**Hunters Hill Local Area  
Traffic Committee  
26 June 2025 at 10:30am**

# AGENDA

<b>ITEM NO</b>	: 3.3
<b>SUBJECT</b>	: WOOLWICH ROAD NEAR FRANKI AVENUE - PROPOSED WOMBAT CROSSING
<b>STRATEGIC OUTCOME</b>	: SAFE WALKING, CYCLING, AND ACTIVE TRAVEL IS SUPPORTED AND ENCOURAGED WITH IMPROVED INFRASTRUCTURE.
<b>ACTION</b>	: IMPLEMENT THE RECOMMENDATIONS OF THE LOCAL TRAFFIC COMMITTEE
<b>REPORTING OFFICER</b>	: LEANNE STATHAKIS

## HUNTERS HILL BIKE PLAN - SITE 15 WOOLWICH RD/ FRANKI AVE INTERSECTION WORKS

PROJECT  
HUNTERS HILL BIKE PLAN -  
SITE 15  
WOOLWICH RD FRANKI AVE  
INTERSECTION WORKS

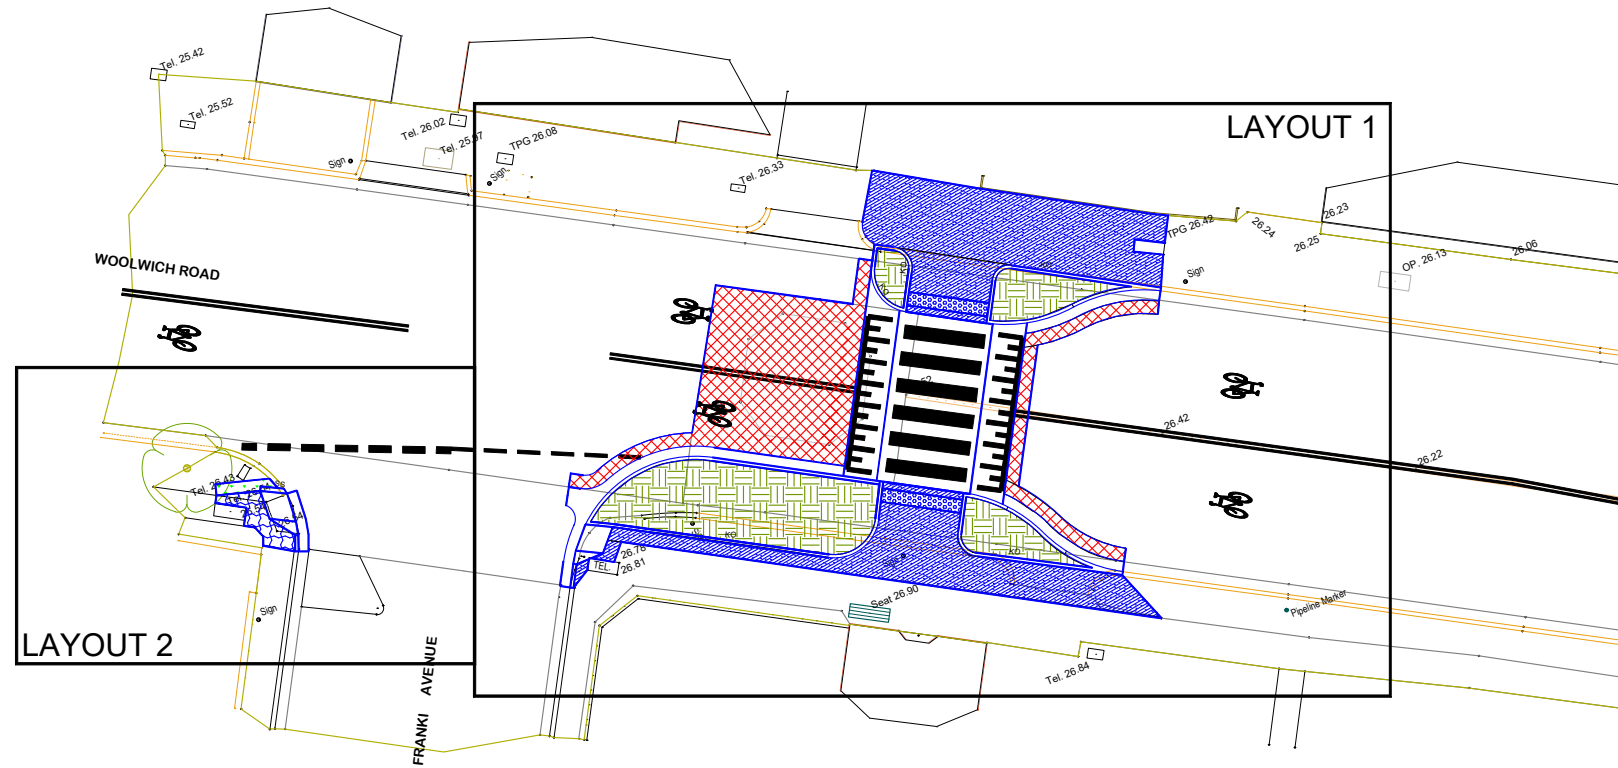
- Confirmation of the statutory 'No Stopping' requirements on the approaches and departure of the crossing
  - LT Urban Response - *The No Stopping distances have been reduced to 7.5 m on the approach since kerb extensions of 2.5m wide have been used. This is as per TfNSW TDT 2002/12b - Stopping & Parking restrictions at Intersections & Crossings.*

- Give way line marking standards – Giveaway Line marking not parallel to Woolwich Road.
  - LT Urban Response - *The give way line marking has been moved out into Woolwich Rd at Franki Ave so the eastern end (Right Side) is out along the kerb extension. This allows the vehicles exiting Franki Ave to be further into Woolwich Rd and provides more sight distance for these vehicles looking in both directions along Woolwich Rd.*

- Swept (turning) path confirmation
  - LT Urban Response – *Swept paths provided in attachments*
- Minimising lane widths to 3.2m wide and moving the crossing to the east to allow for kerb extension

- Confirming that the crossing is 3.6m wide
  - LT Urban Response - *Yes the crossing width is 3.6m wide.*
- Could a Kerb extension be considered at Franki Avenue to reduce crossing width across Franki Avenue

- LT Urban Response - *Kerb extensions in Woolwich Rd are 2.5m wide for both sides of the street, in the current design. The kerb extensions provide good sight distance in both directions along Woolwich Rd. The crossing distance has been reduced by 5m. The 3.2m lane width cannot be achieved at this location since bus movements for the approach and departure to & from the bus stops to the east of the pedestrian crossing require the current lane widths. Widening the kerb extensions would also impact the swept paths for a car exiting the driveway of No. 102 and the left turn from Woolwich Rd into Franki Ave for a 8.8m service vehicle.*

- LT Urban Response - *The kerb extension is possible. It would be an increase to the project scope.*
- Possibility of kerb extension on the NW side to increase outdoor dining space-

- LT Urban Response - *Extension of the kerb build out west to the frontage No. 102 would result in loss of 2 on street car spaces.*
